15557-TUL-XX-XX-RP-C-91002 Issue 01

Land East of Longwater Road, Finchampstead, Longwater Road, Wokingham, RG40 3TS.

Discharge of Condition Consultation (Application Number 260289)

Planning Response for Conditions 7, 9 & 11.

GUI003-TUL-XX-00-DR-C-95-326

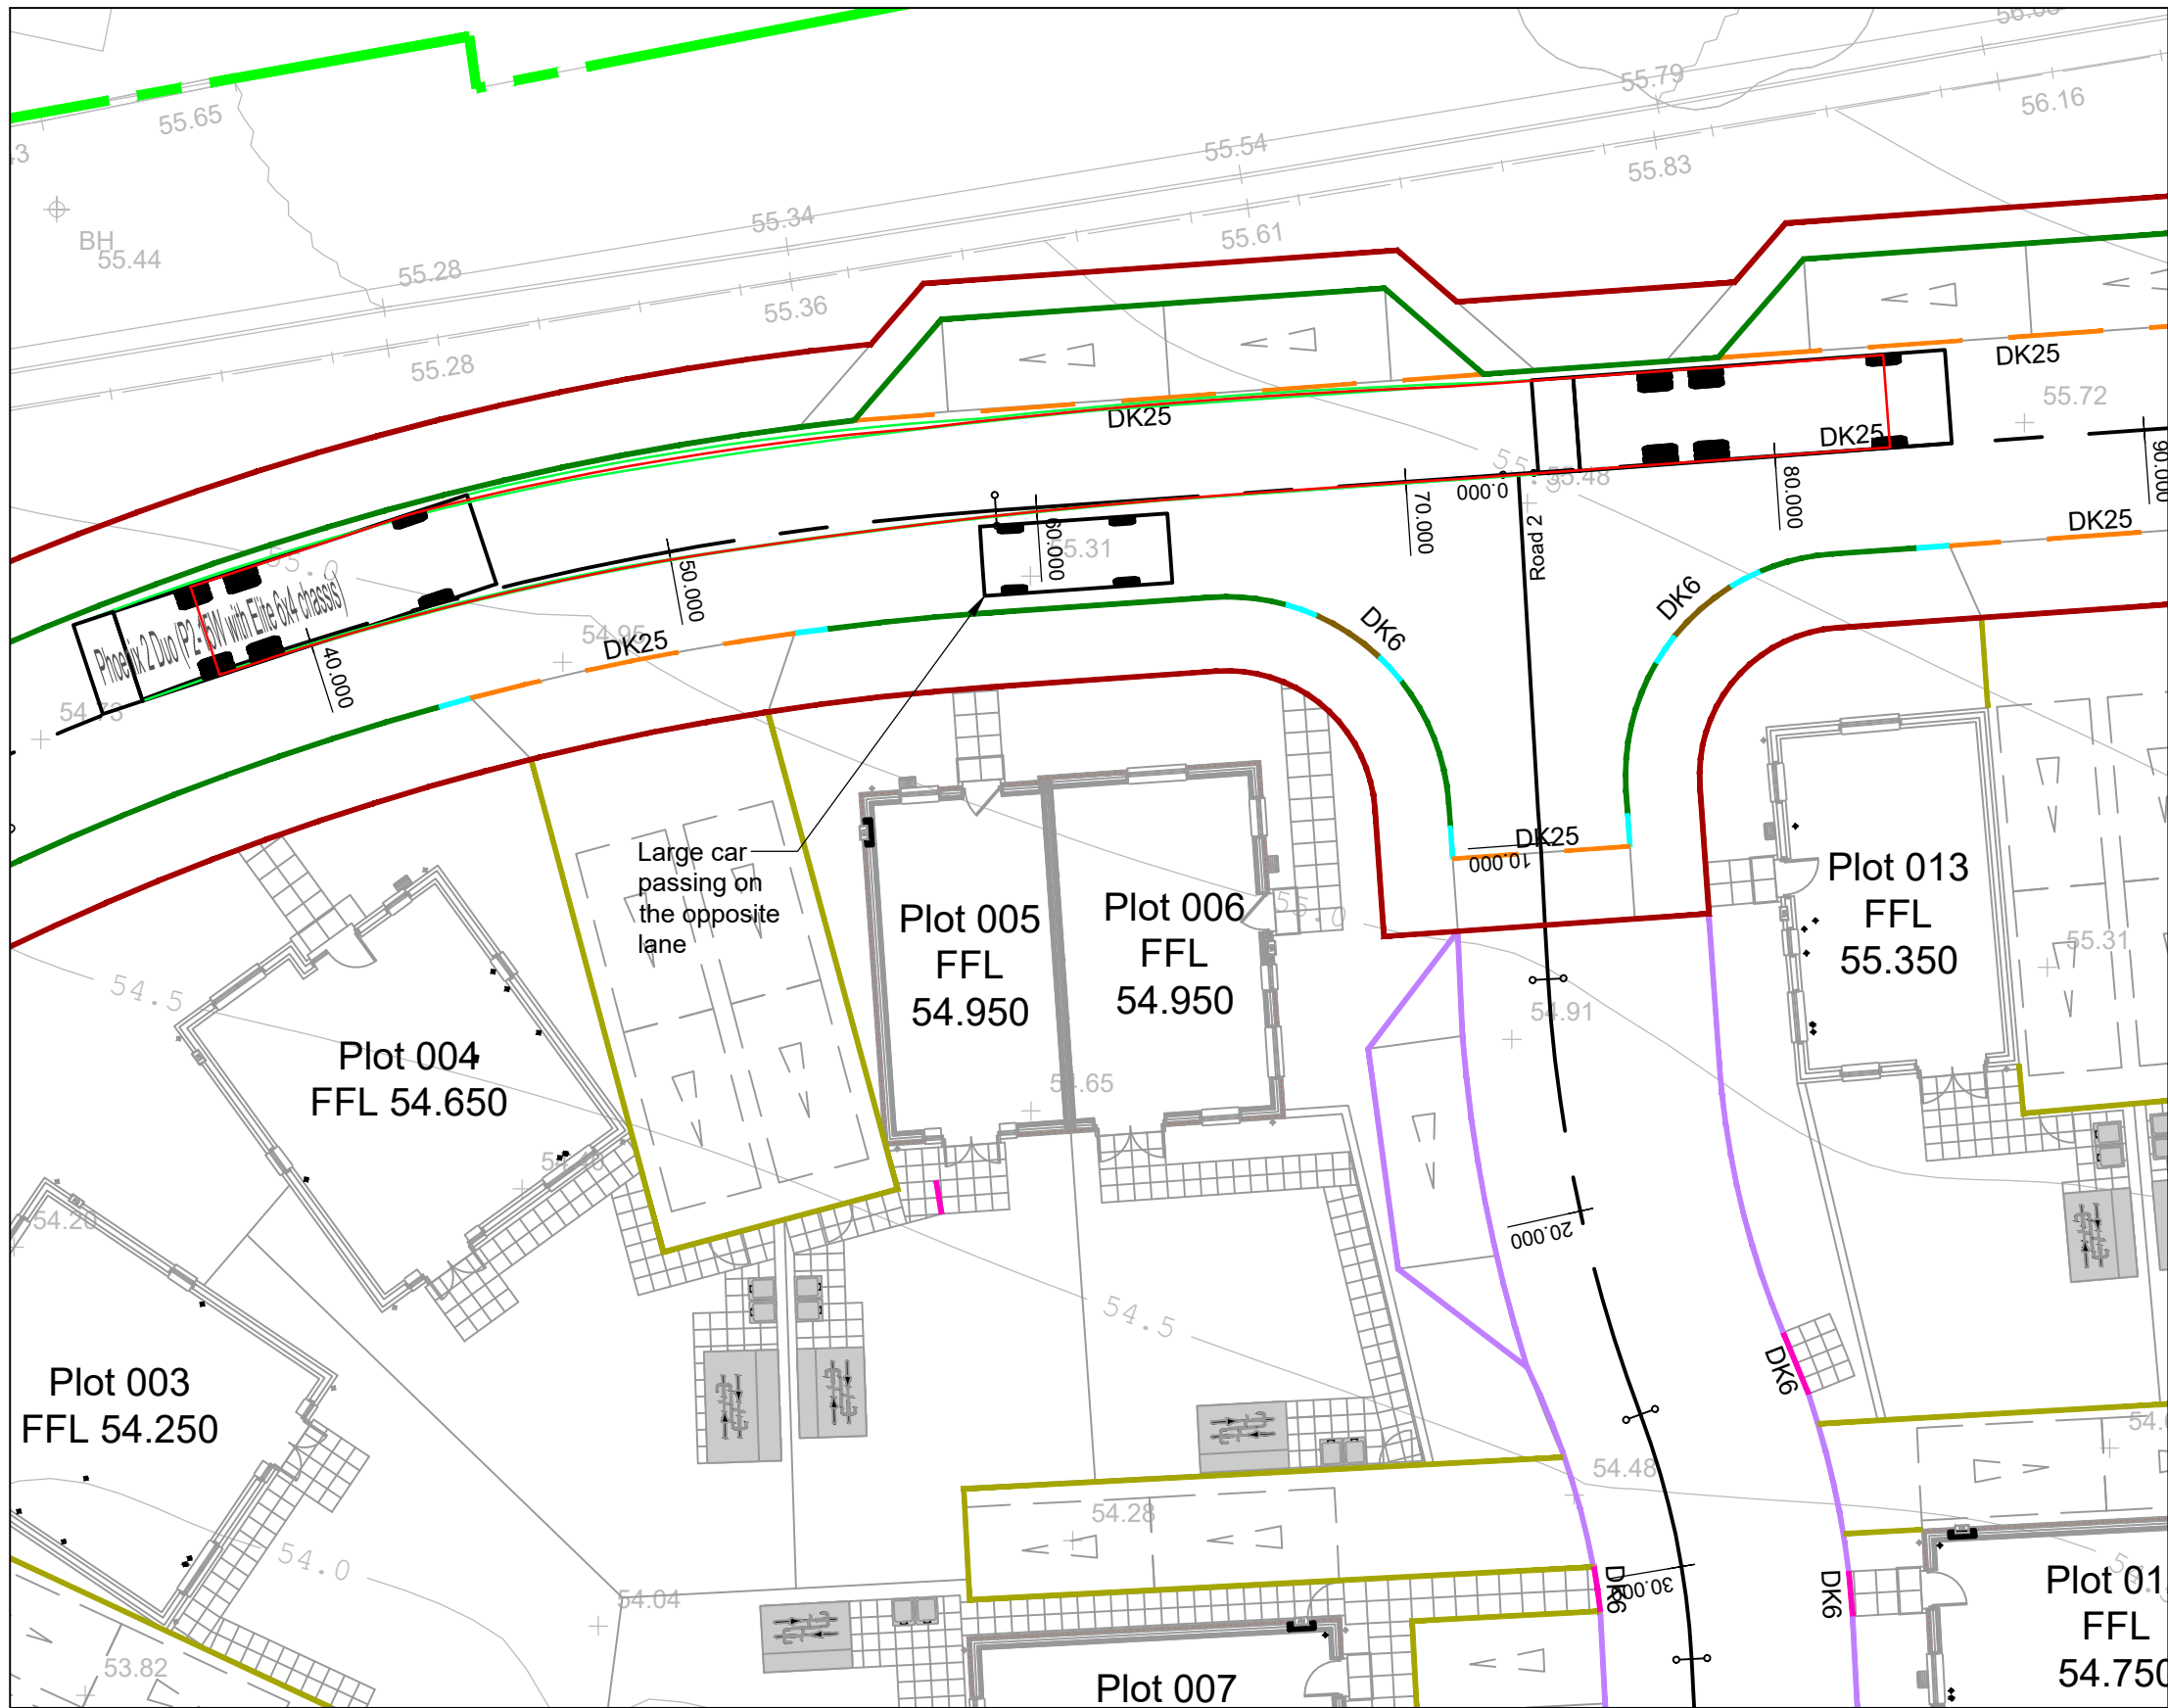
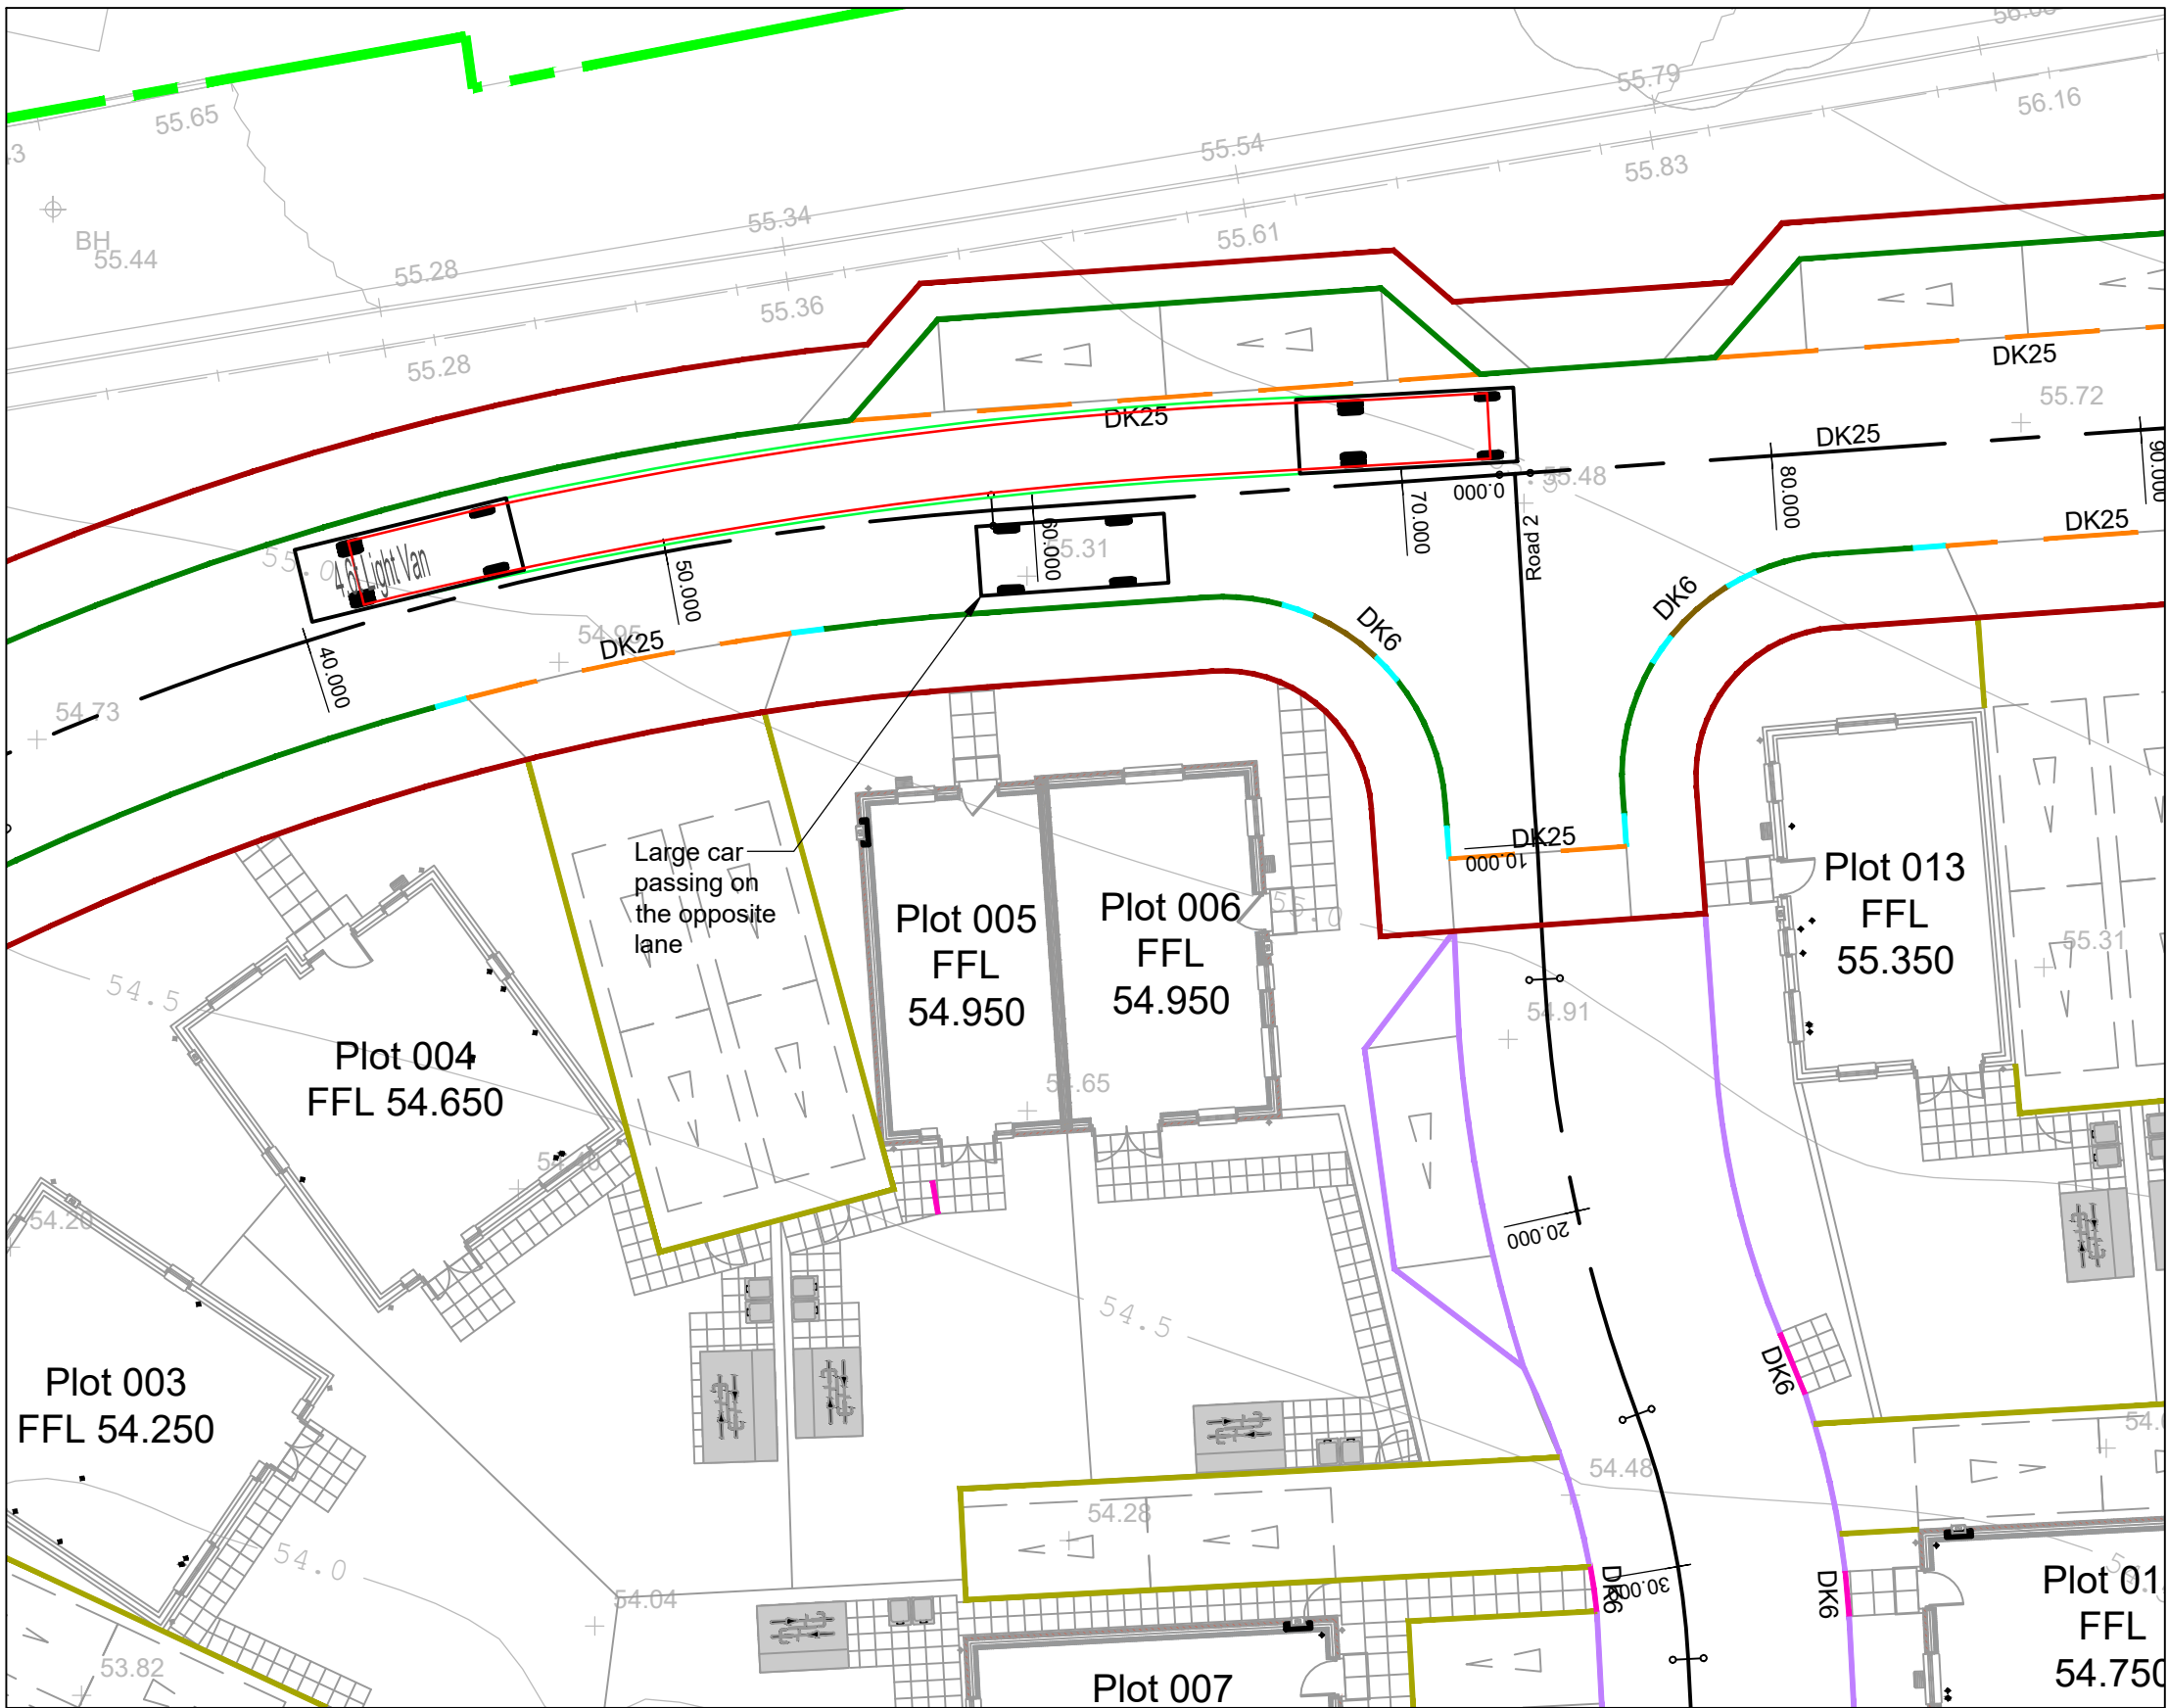
- *Width of the parking bays proposed on site should be clarified/confirmed.*
- *Swept path analysis is required for the internal roads which show a refuse vehicle and delivery van can pass a large modern car. Swept paths for a large modern car should also be completed for the car parking spaces proposed on site.*

- *Forward visibility cannot be checked at bends without the submission of swept path analysis.*
- *Haunching needs to extend past the edging.*
- *All conduits to be SD4 instead of SD2.*

- Swept paths provided for refuse vehicle and delivery van passing and car for parking spaces.

Refer to drawings GUI003-TUL-XX-00-DR-C-95-325_P01, GUI003-TUL-XX-00-DR-C-95-326_P01.

- Forward visibility curve added.

Refer to drawing GUI003-TUL-XX-00-DR-C-95-326_P01.
